# Service Campaign Bulletin

Campaign No. 2012070002, September 2012

SUBJECT: **Models 164, 171, 203, 204, 207, 209, 211, 212, 216, 219, 221, 230, 251, 463**  
**Engines 272 and 273**  
**Model Years 2005 - 2011**  
**Retrofit Adapter Wiring Harness on Camshaft Adjustment Solenoids**

Figure 1

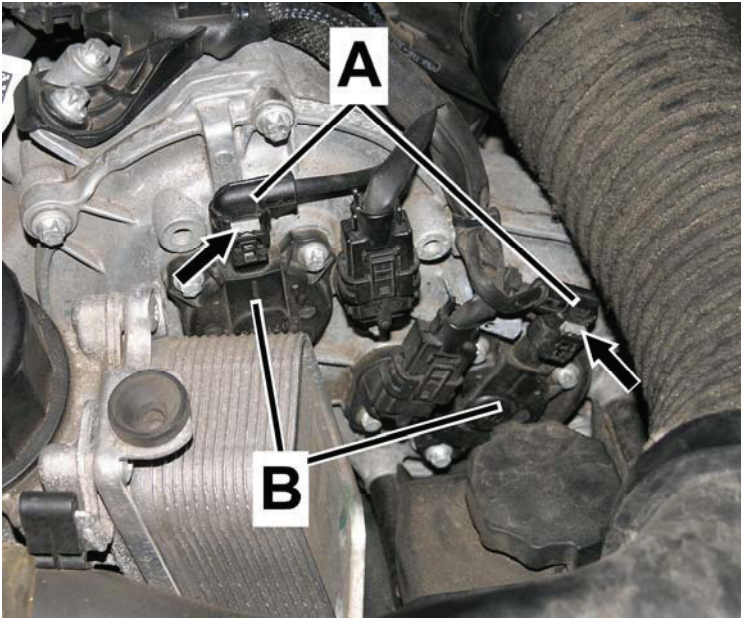
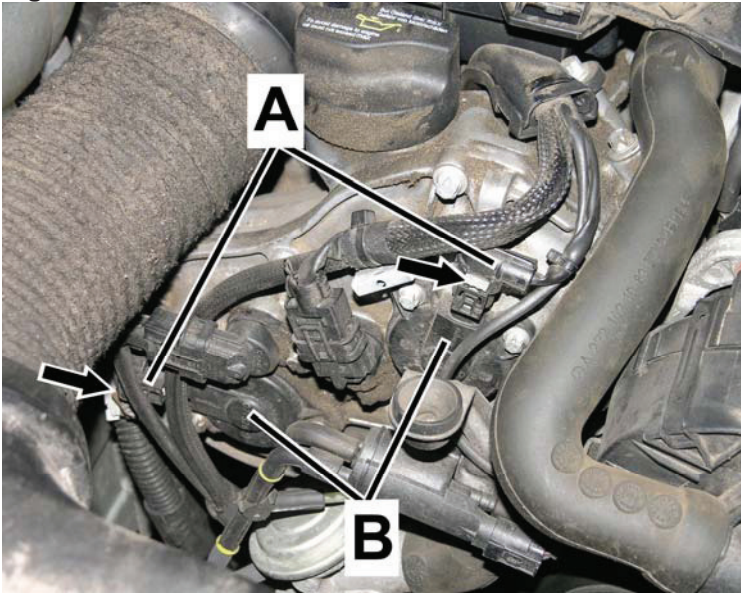
1. Remove top engine cover to get access to camshaft adjustment solenoids as required.
2. Disconnect camshaft adjustment solenoids from engine harness connectors (A, Figures 1 and 2):
  - Carefully unlock engine harness connectors (A) by squeezing and **partially** pulling out locking tabs (arrows) using pocket screw driver.
  - Disconnect camshaft adjustment solenoid connectors (A) from camshaft solenoids (B).

Figure 3

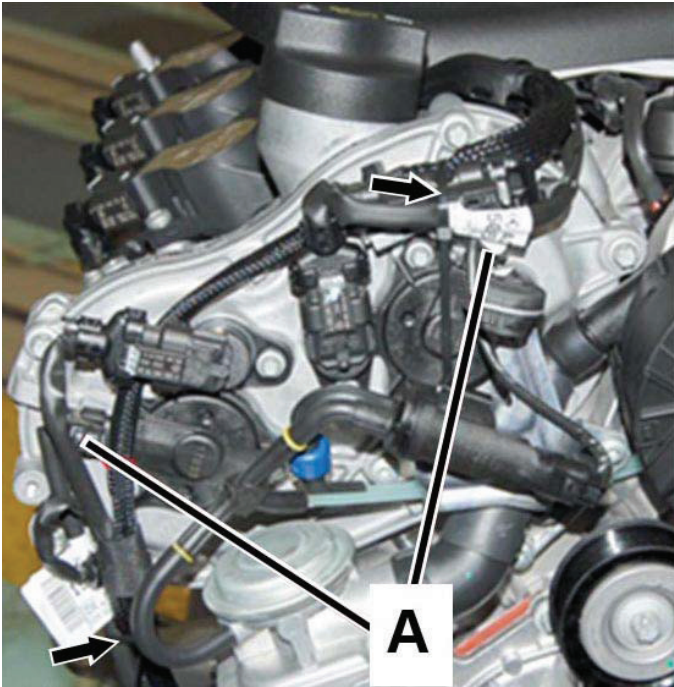
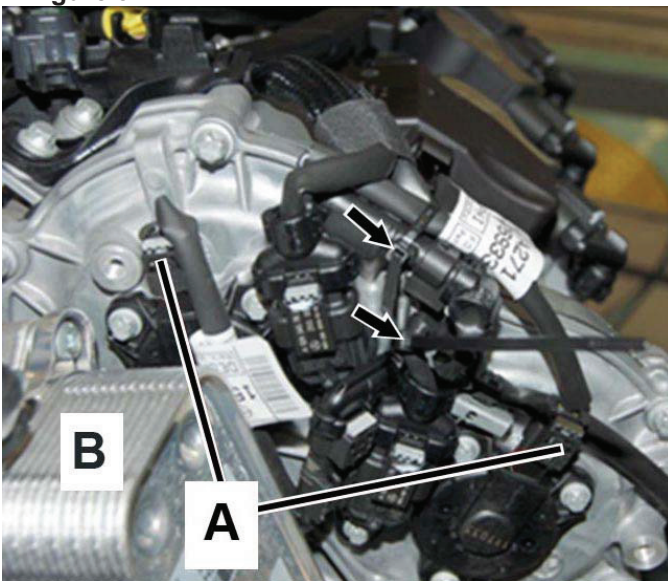
3. Connect adapter harnesses (A, Figures 3 and 4):
  - Connect adapter harnesses (A) between connector on camshaft adjustment solenoid and engine harness.
  - Push locking tabs (arrows, Figures 1 and 2) into connectors to secure (total of 8 locking tabs).
4. Secure adapter harnesses with cable ties.

Ensure harness adapters are properly secured using cable ties (arrows, Figures 3 and 4) to prevent wire chafing and/or damage from hot engine parts, (e.g. oil cooler [B]).
